# City of Tualatin

## ARCHITECTURAL REVIEW FINDINGS AND DECISION

Case #: AR15-0023  
 Project: Arby's to Starbucks Conversion Remodel  
 Location: [17771 SW Lower Boones Ferry Rd, Lake Oswego](#) (postal address) (Tax Lots 21E 18BC 01000 & 21E 18CB 01900)  
 Applicant: Sarah Vaz, Holst Architecture (503-233-9856; Job No. 07870-026); Mike Berrey, Berrey Properties LLC

title:  
PROPOSED SITE  
PLAN

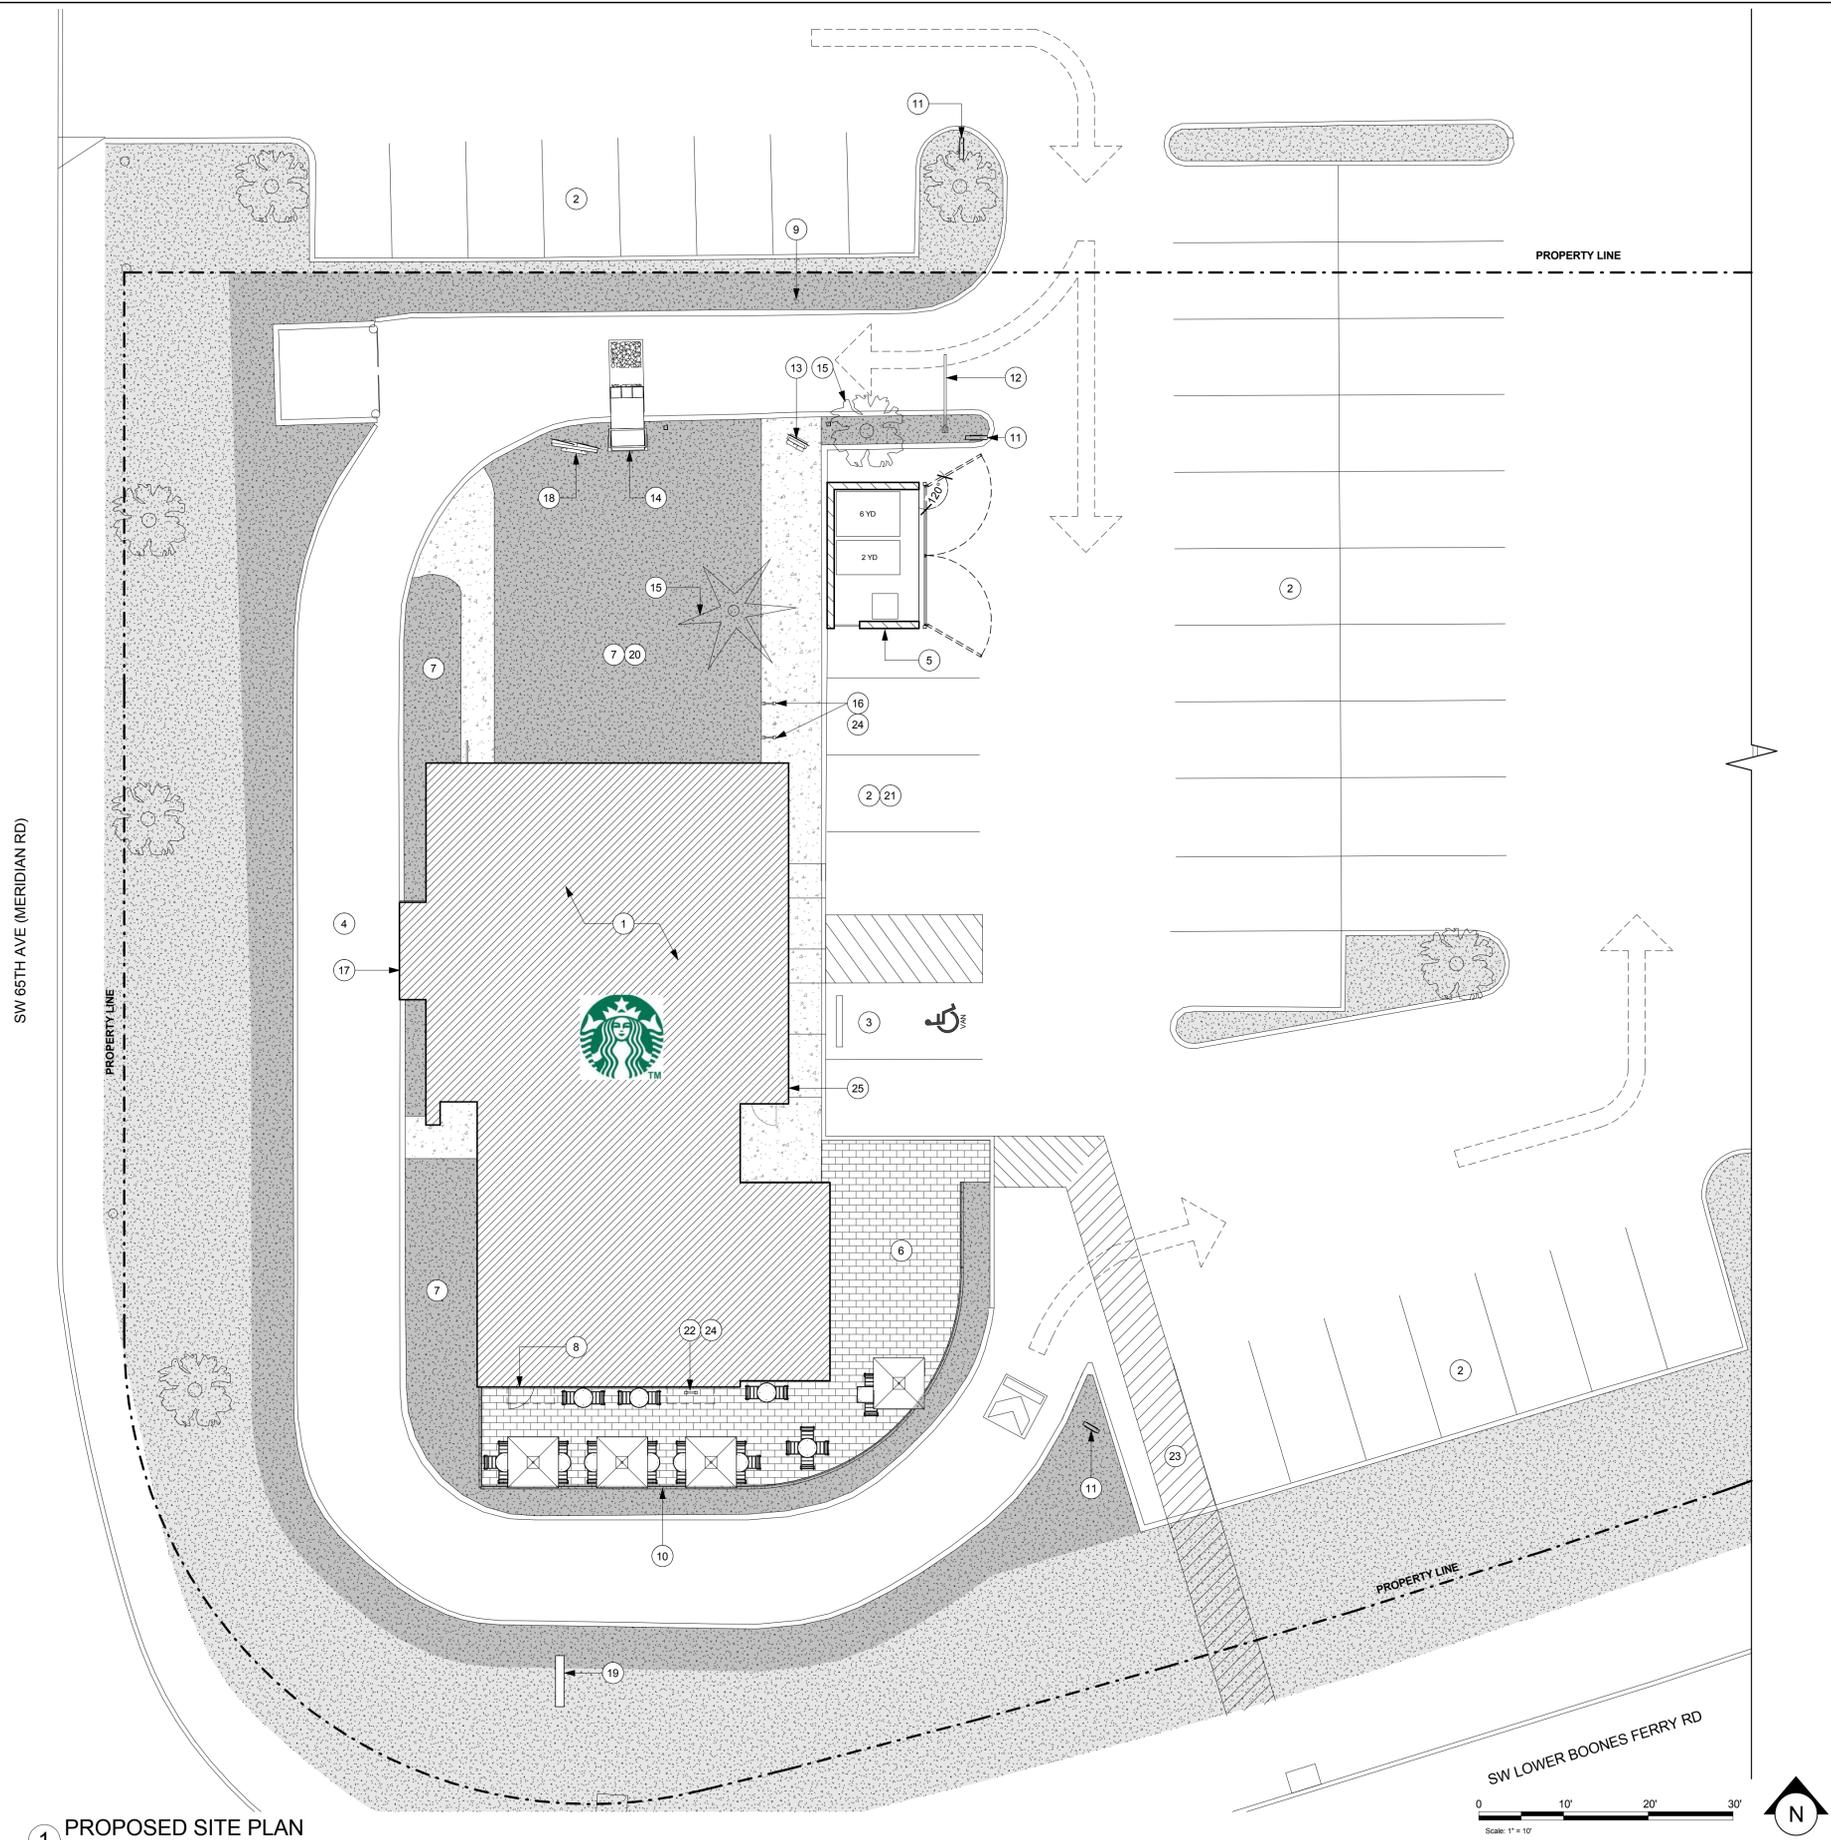
ROW is required. Because the site plan illustrates no accessway, staff is applying a condition to meet the requirement. Because the physical difference between a walkway and accessway is that an accessway is 8 ft wide, 2 ft wider than a 6-foot walkway, a simple way to create an accessway is to widen the proposed walkway to 8 ft.

The site plan illustrates a proposed walkway, but does not illustrate that it will include ramps at curb crossings. Staff applied a condition to meet accessway the requirement of 73.160(1)(iv) above. For these reasons, staff is applying a condition.

The site plan illustrates an enclosure and Note 5 indicates it is designed to comply with 73.227(6). It has a gate opening of 15 ft and gates capable of being secured in a closed and open position, with a separate pedestrian access, and paved flooring; however, because the enclosure walls lack adjacent evergreen plants, staff is applying a condition.

The site plan through Note 21 and its call-out placement indicates provision of two carpool/vanpool (C/V) stalls. Because only a general vicinity is indicated, it is unclear which particular stalls would be designated and marked with striping and/or signage as Note 21 indicates. For this reason, a plan sheet revision is needed, and staff is applying a condition.

- The applicant shall revise the site and landscape plans to indicate an accessway between the restaurant building main entrance and the SW Lower Boones Ferry Road sidewalk, such as through widening the proposed walkway to 8 ft.

- The applicant shall revise the site plan to illustrate a ramp wherever a walkway or accessway crosses a curb.

- The applicant shall revise the site plan to illustrate or note that an accessway is paved.

1. The applicant shall revise the site and landscape plans to illustrate and shall plant evergreen plants around the walls of the replacement recycling and trash enclosure, excluding the gate or entrance openings.
2. The applicant shall provide an elevation view of each of the four sides of replacement recycling and trash enclosure illustrating that it is sight obscuring and 6 ft high.

- The applicant shall revise the site plan to indicate the specific carpool/vanpool (C/V) stall or stalls and symbolize their striping and/or signage.

**Architectural Review** title: LANDSCAPE PLAN sheet: **L1**  
11/01/2015

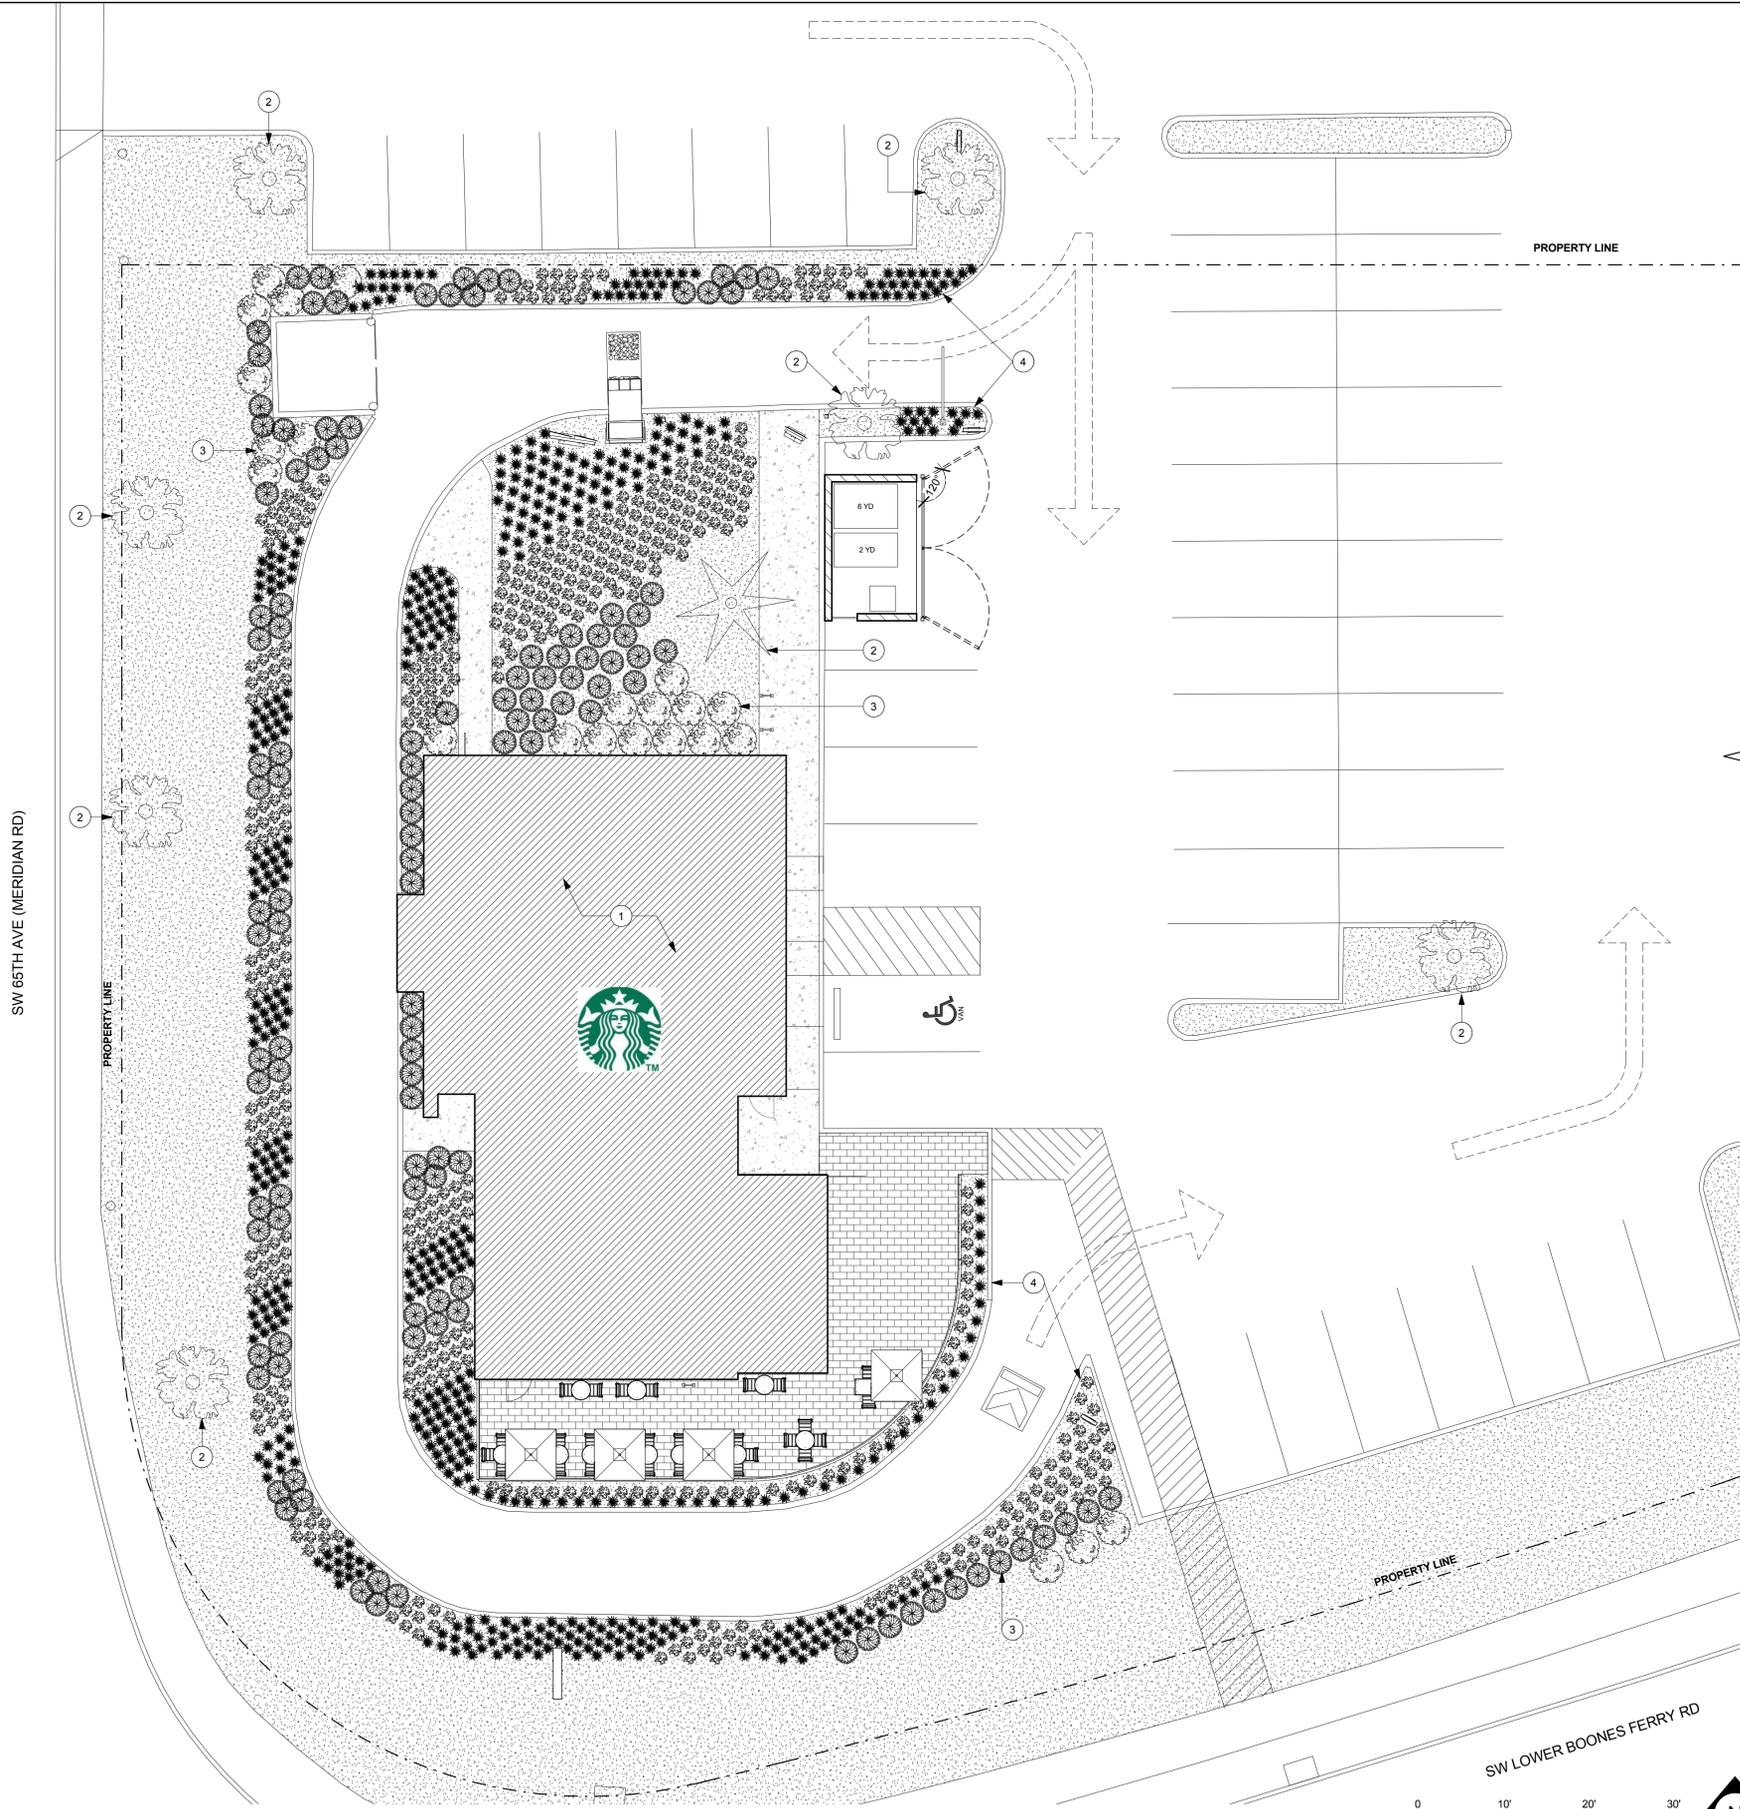
The landscape plan illustrates the west yard along SW 65<sup>th</sup> Avenue planted to lawn and live groundcover and with trees and shrubs. The south yard along SW Lower Boones Ferry Road is planted to lawn and live groundcover and with a tree and shrubs. (Though the plan sheet does not show trees in the south front yard, the staff site visit on October 21, 2015 found that

The landscape plan illustrates as landscaped all areas not occupied by buildings, parking spaces, driveways, drive aisles, pedestrian areas or undisturbed natural areas, excepting two remnant paved areas. For these reasons, staff is applying a condition.

The second is on the north side of the proposed recycling and trash enclosure that is not useful for anything in particular. Because staff applied a condition to meet the enclosure evergreen plants requirement of 73.227(6)(b)(iii) above, complying with that condition can substantially or fully meet this condition for this second area.

- Because staff applied a condition to meet the enclosure evergreen plants requirement of 73.227(6)(b)(iii) above, complying with that condition can substantially or fully meet this condition for this second area: The applicant shall revise the site and landscape plans to illustrate and shall plant evergreen plants around the walls of the replacement recycling and trash enclosure, excluding the gate or entrance openings.
